SUBJECT: Supplement #1A to the Application for Certification
Rio Mesa Solar Energy Generating Facility (11-AFC-4)

DATA ADEQUACY SUPPLEMENT 1A

Response to Data Adequacy Review of the APPLICATION FOR CERTIFICATION for the Rio Mesa Solar Electric Generating Facility

Water Responses to Data Adequacy Review

See Figure 1. Cross-sectional diagram of the evaporation ponds.

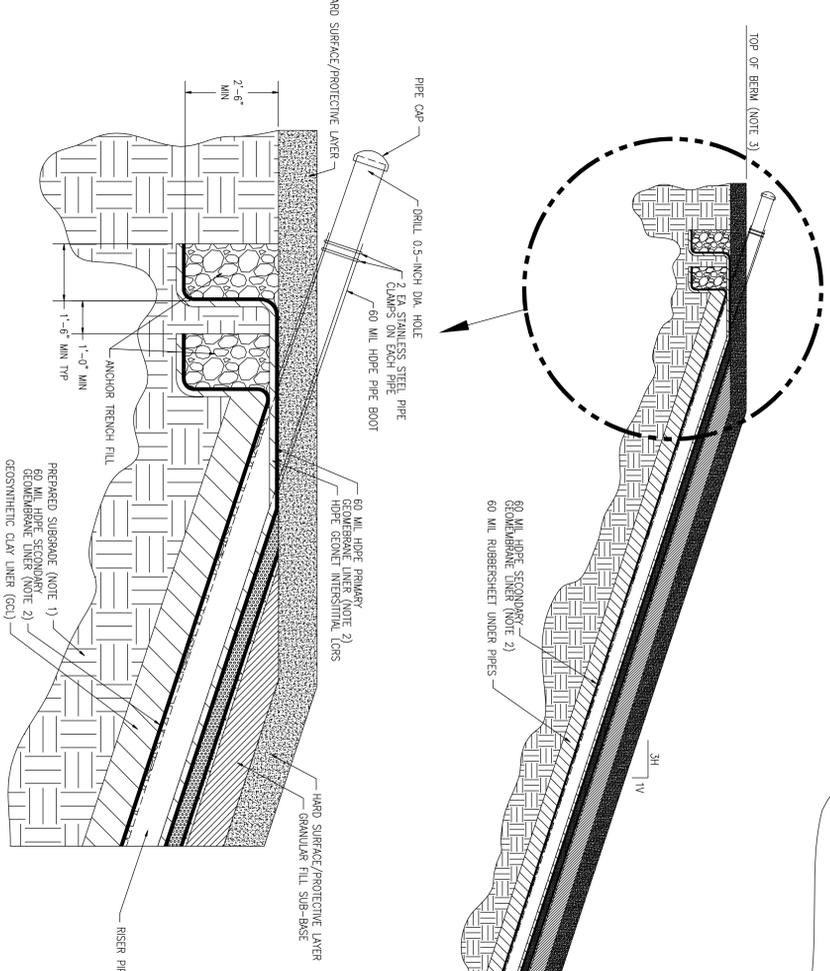
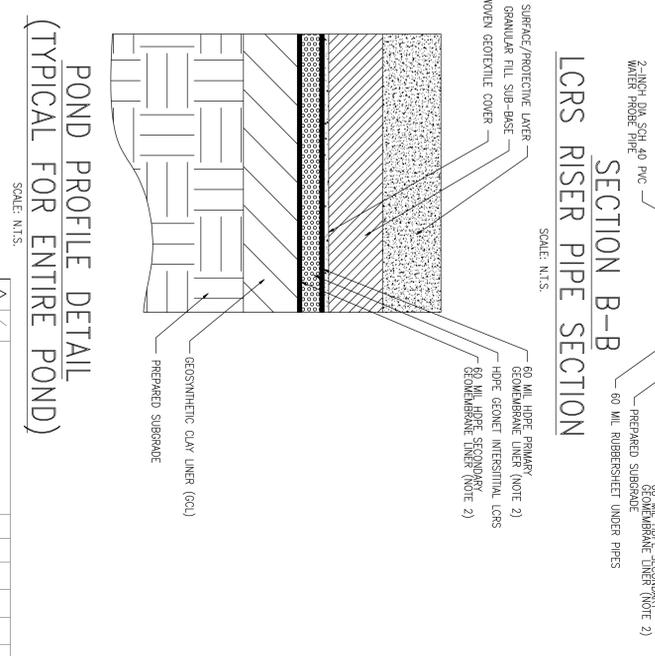
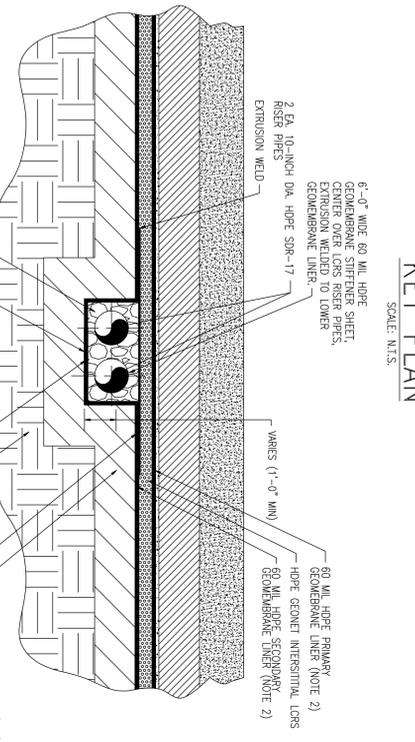
CEC Requirement (1): Design data for the Evaporation Ponds.

The two, two (2) acre evaporation ponds will be designed with a primary and secondary liner system and an intervening leak collection and recovery system (LCRS). The LCRS design provides for capture and conveyance of the seepage through the upper primary liner to a collection sump. LCRS sumps will be included in the design of each evaporation pond cell. Solution collected in the LCRS sumps will be pumped using a mobile pump, and returned to the evaporation ponds. These evaporation ponds will be designated as Class II Surface Impoundments Waste Management Units (WMU) and will meet the requirements of the California Code of Regulations (CCRs), Title 27, CCR §20200 et seq.

The evaporation pond design utilizes a double liner system with an intervening Leak Collection and Recovery System (LCRS) for groundwater protection and enhanced seepage protection, as follows (from top to bottom):

- Hard surface Protective Layer
- Non-woven geotextile
- 60-mil high density polyethylene (HDPE) upper (primary) geomembrane;
- An interstitial LCRS consisting of HDPE geonet;
- 60-mil HDPE lower (secondary) geomembrane;
- Reinforced geosynthetic clay liner (GCL) as the underliner component of the secondary composite liner system; and
- Prepared subgrade

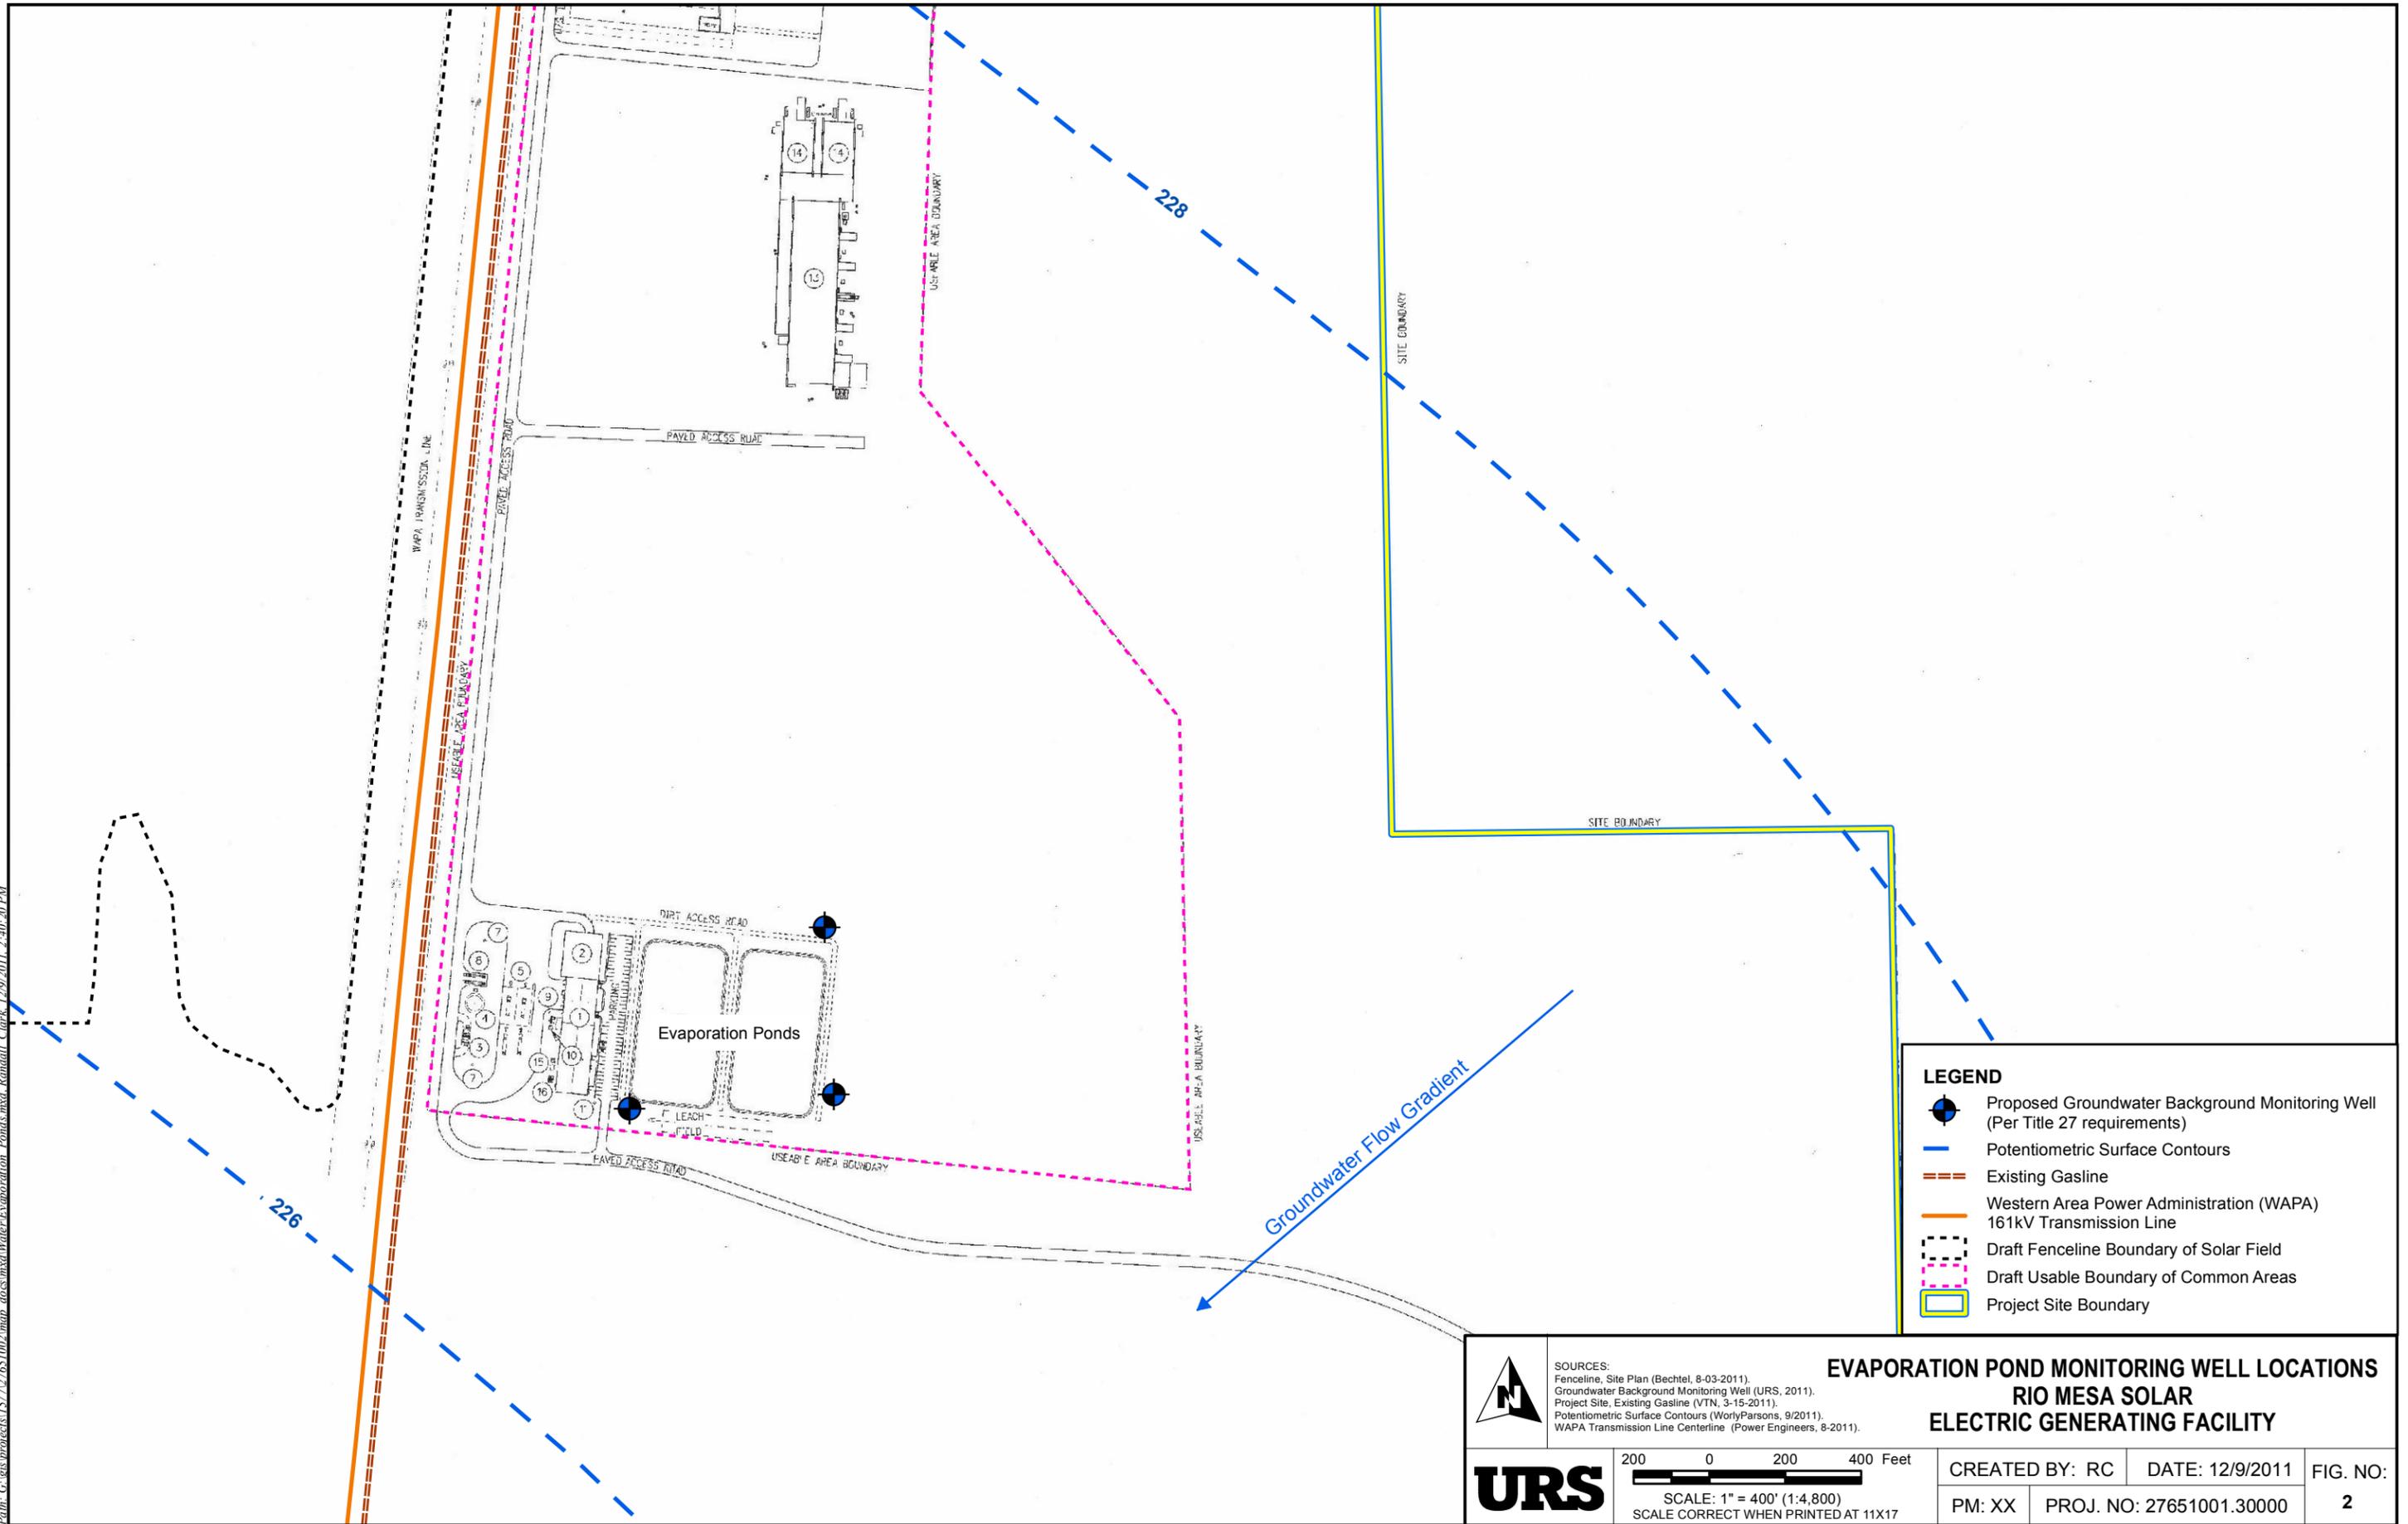
CEC Requirement (4): Basis of design for the monitoring wells and general location depicted on a drawing.

Monitoring wells will be installed per Riverside County requirements and will be installed within the first encountered groundwater and be screened within approximately 5 feet above the water surface elevation and extend 25 feet below the water surface elevation. See Figure 2 for the proposed well locations.
